SNS-OPM-ATT 2.B-10.a.
Unreviewed Safety Issue (USI) Evaluation Form

USI Evaluation for PPS Power Supply Wiring Modifications and Implementation of Watchdog Diagnostics to Mitigate Common Mode Failures

Figure 2. PPS Intersegment Communications

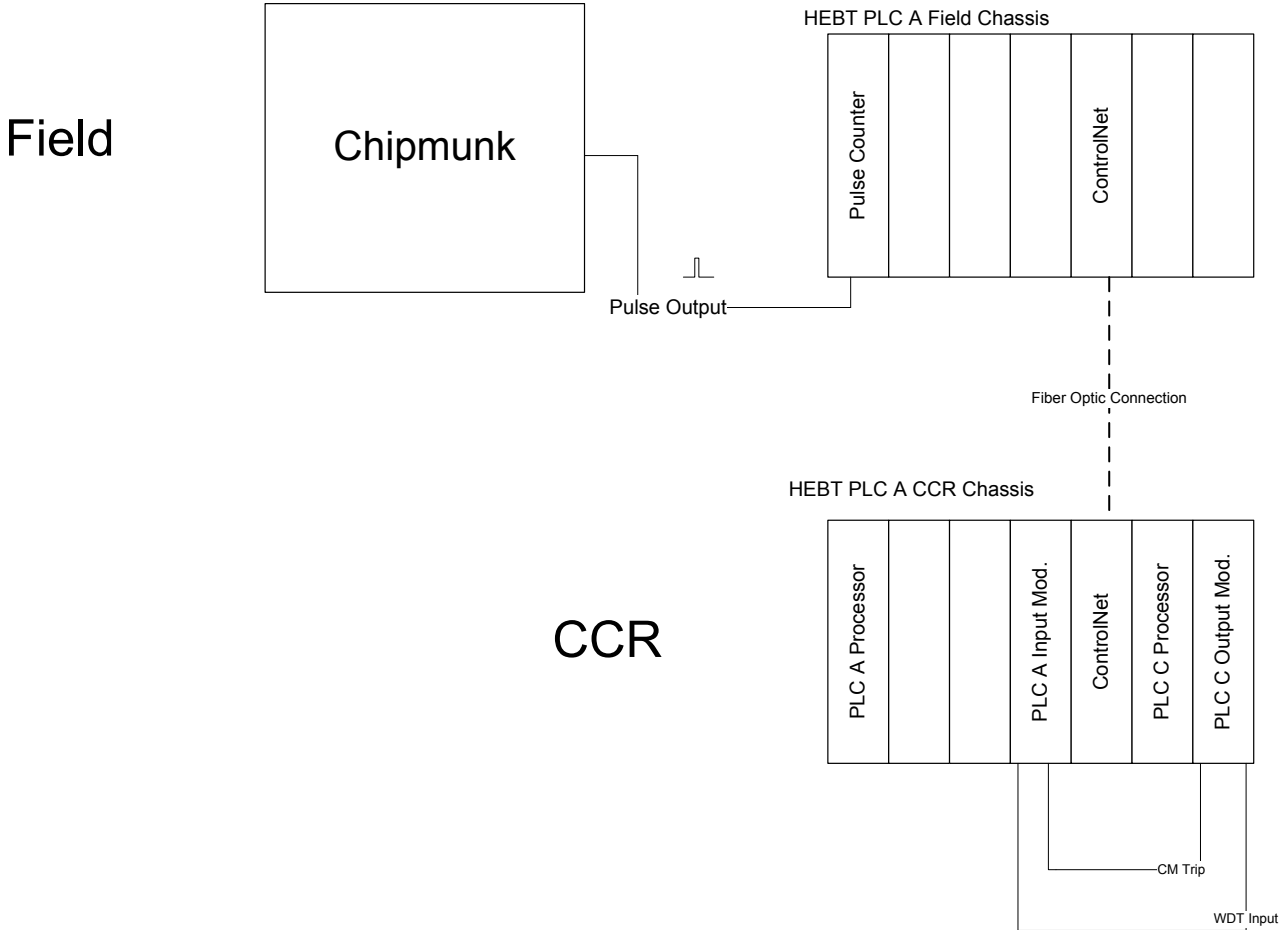
As described above, the five PPS segments communicate with each other via intersegment communications as depicted in the simplified diagram presented in Figure 2. Each line depicting communication between segment outputs and segment inputs represents multiple inputs/output communications between the segments. For example, there are 6 unique HEBT PLC output/LINAC PLC input communications (3 for PLC A and 3 for PLC B), all represented by the single arrowed line in Figure 2. A watchdog diagnostic will be added to each unique intersegment PLC output/PLC input pairing for a total of 6 watchdog diagnostics for HEBT/LINAC intersegment communication. The number of watchdog diagnostics associated with communications between segments is indicated in Figure 2. Wiring will be installed to transmit each watchdog signal between modules.

Figure 6. Proposed PLC Power Supply Wiring Scheme for the HEBT, RING, RTBT, and Target PPS Segments

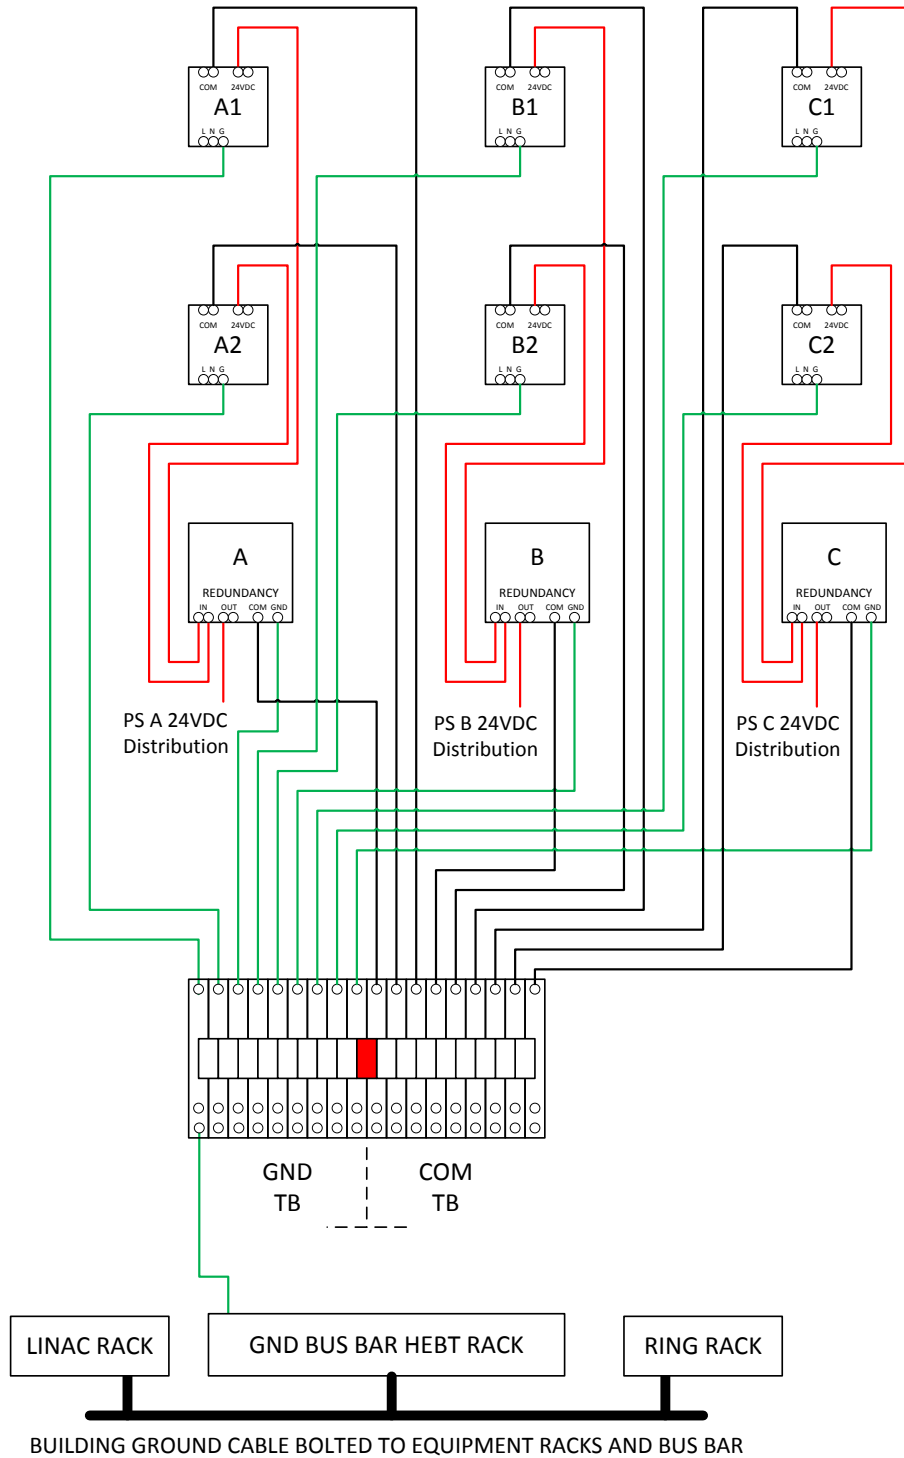
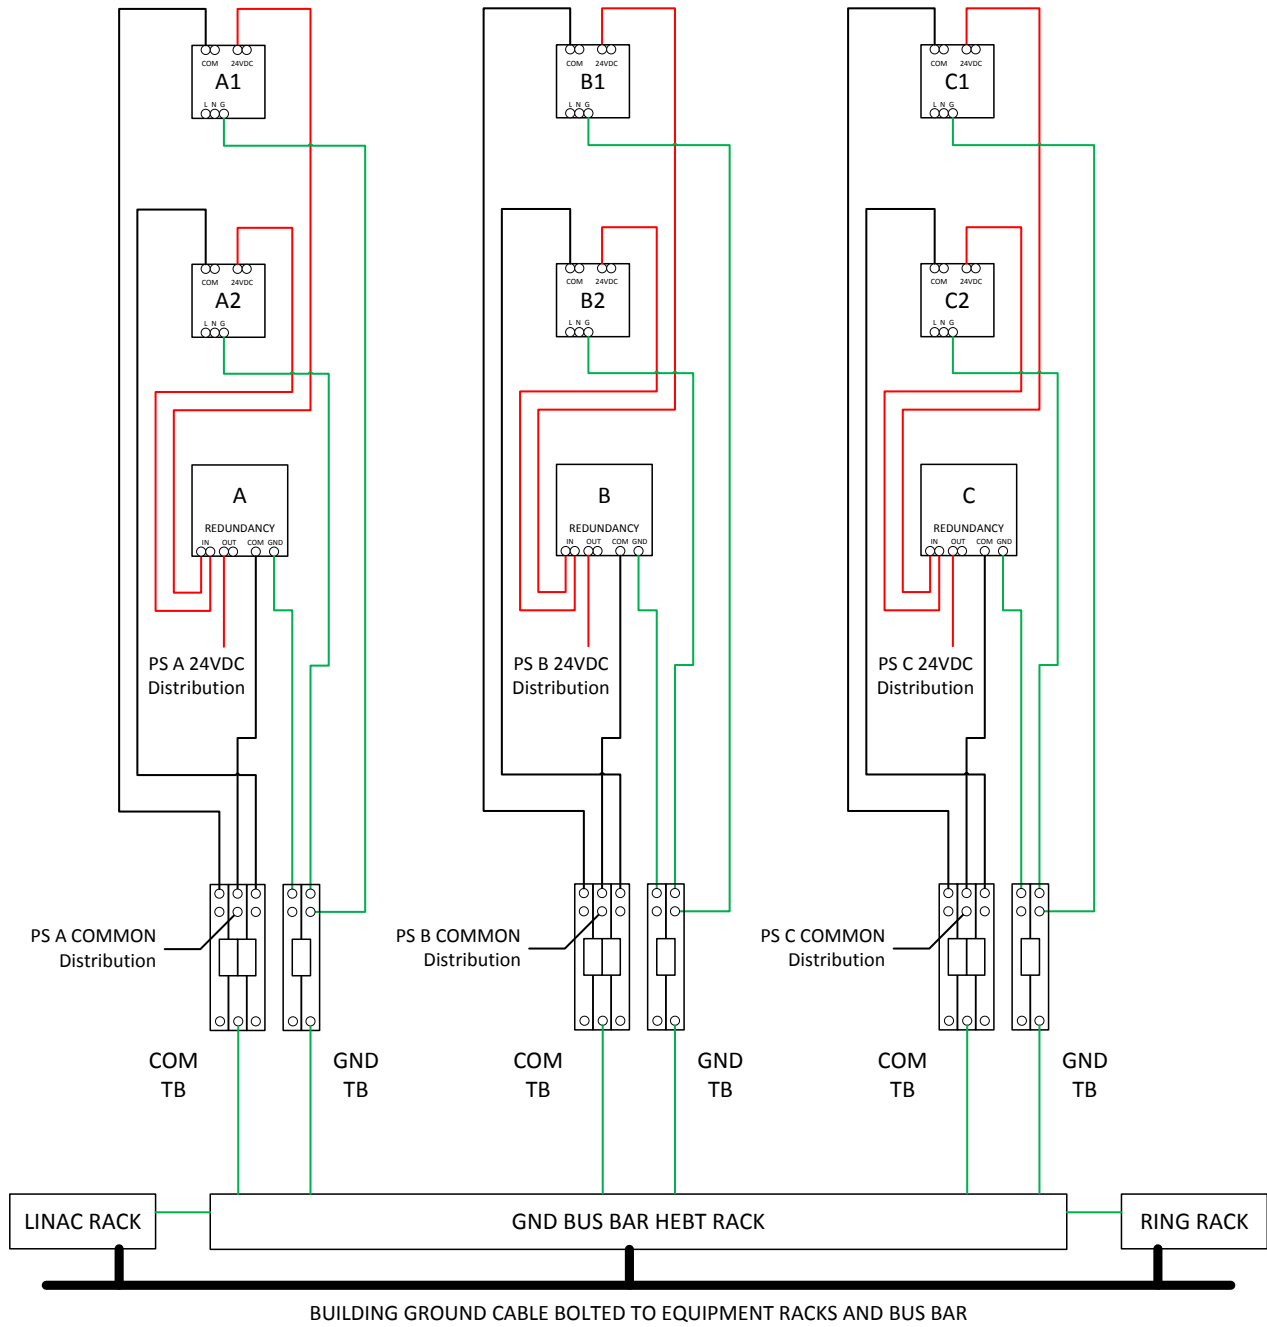
The existing power supply-wiring scheme for the HEBT, RING, RTBT and Target CCR PPS racks is shown in Figure 4. The existing power supply-wiring scheme used for the LINAC PLC segment is shown in Figure 5. Note that the LINAC does not have PLC Channel C power supplies in its CCR rack but does include the power supply for the Chipmunk Panelview system.

The wiring shown in Figure 6 is proposed to eliminate the possibility that loss of any single connection could render both Channel A and B inoperable. The proposed wiring configuration of Figure 6 accomplishes the following:

- Separates PLC A, PLC B and PLC C power supply wiring from each other
- Provides multiple return paths from each terminal strip assembly such that a single wire fault can only affect a single channel (i.e. will not result in a common mode failure)
- Provides redundant earth ground wiring between racks to protect against the loss of earth ground due to a single fault.

Figure 7. Proposed PLC Power Supply Wiring Scheme for the LINAC PPS Segment

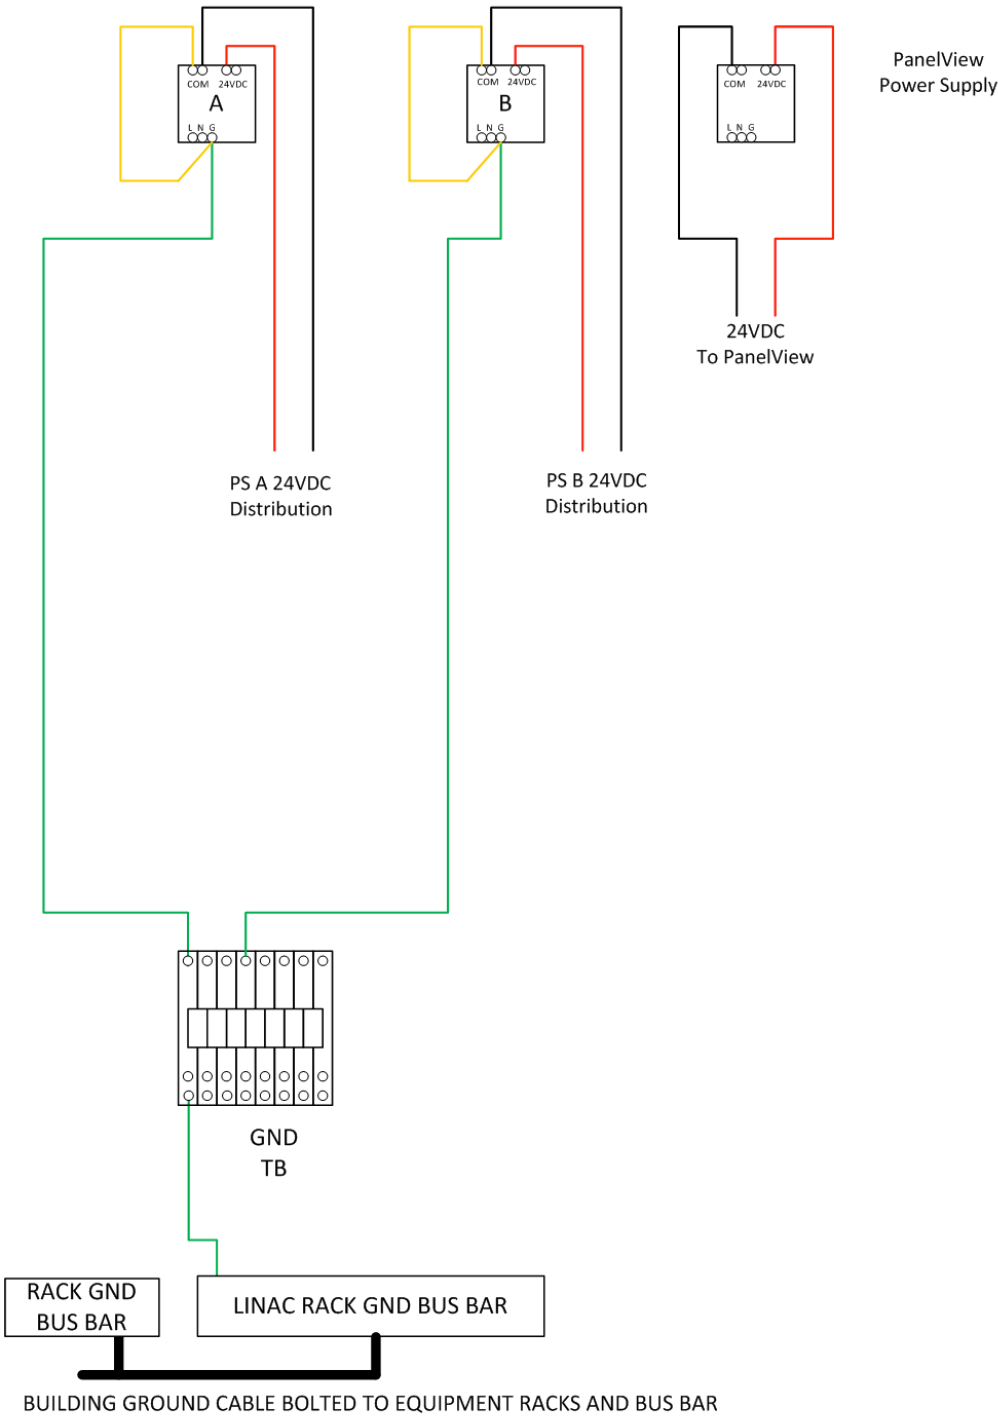
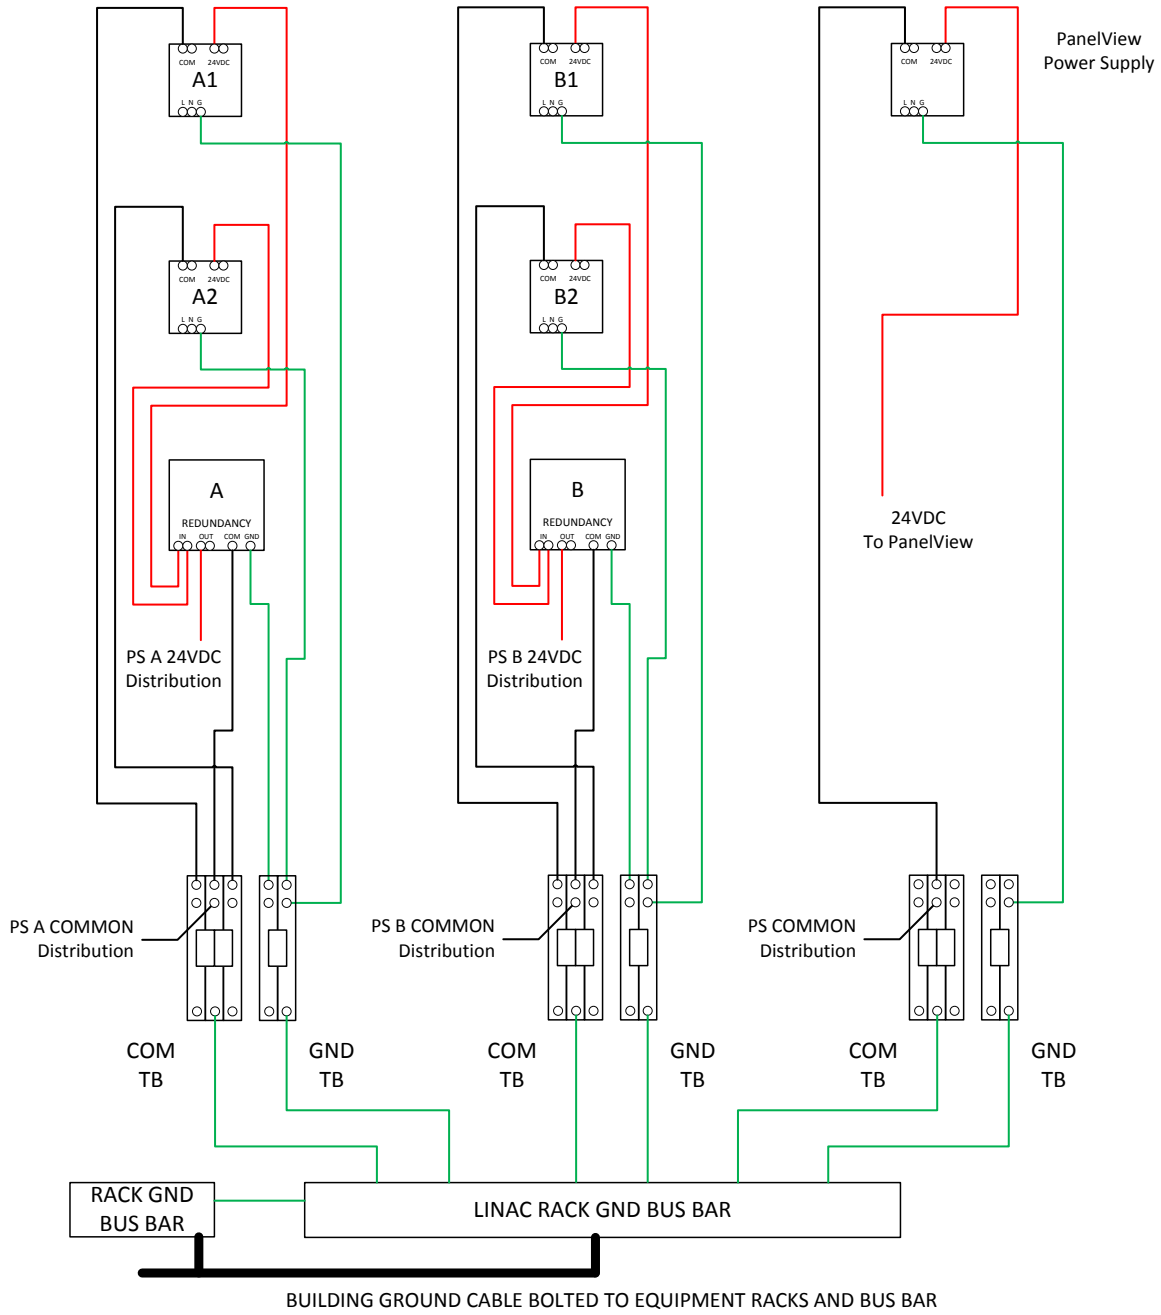
Because the single power supply system in the LINAC segment has a similar vulnerability, it is proposed to install redundant power supplies in the LINAC CCR rack in accordance with the wiring modifications described in the section below. Therefore the LINAC CCR rack will be wired in the same fashion as each of the other segments (see Figure 7).

Figure 8. **Example of PPS Intersegment Wiring Between a HEBT and LINAC Module**
(The lower tier represents the proposed watchdog diagnostic.)

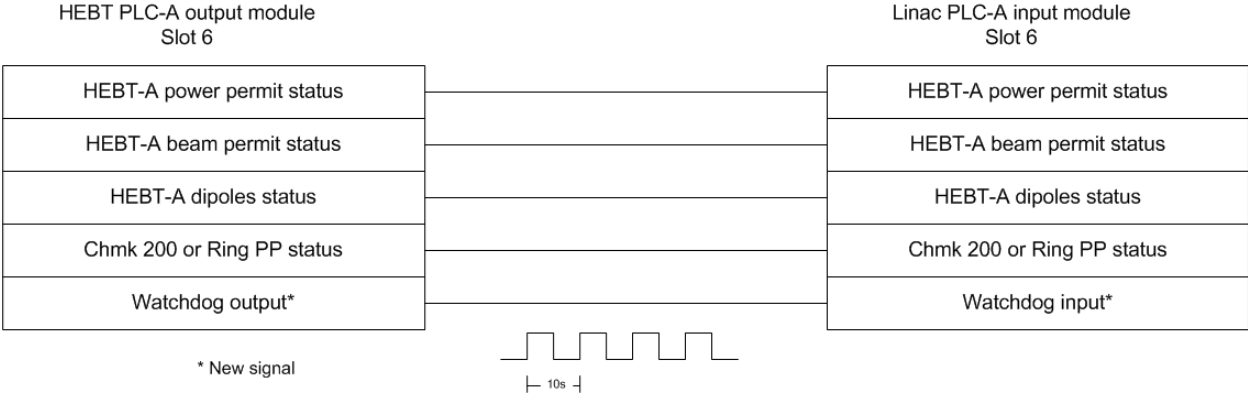
Figure 8 depicts an example of the wiring between a single HEBT output to LINAC input module for a single channel (e.g. Channel A). An oscillating watchdog signal will be transmitted from the output module to the input module across a newly installed wire as shown at the bottom of the diagram.

Programming will be added to each PLC processor to drive a new output signal alternating high and low at a 10 second cycle time. This new output signal will be sent to the corresponding input module in the next segment. Programming will be added to the receiving segment to examine the watchdog output to determine if it is changing state as intended.

If the diagnostic programming detects that an inter-segment watchdog input function has failed then the receiving segment will act to terminate beam operations in an analogous manner as if a real unsafe trip signal had been issued by the output module. All segments of the PPS (except for the Target PPS which does not receive inter-segment inputs) control at least one critical
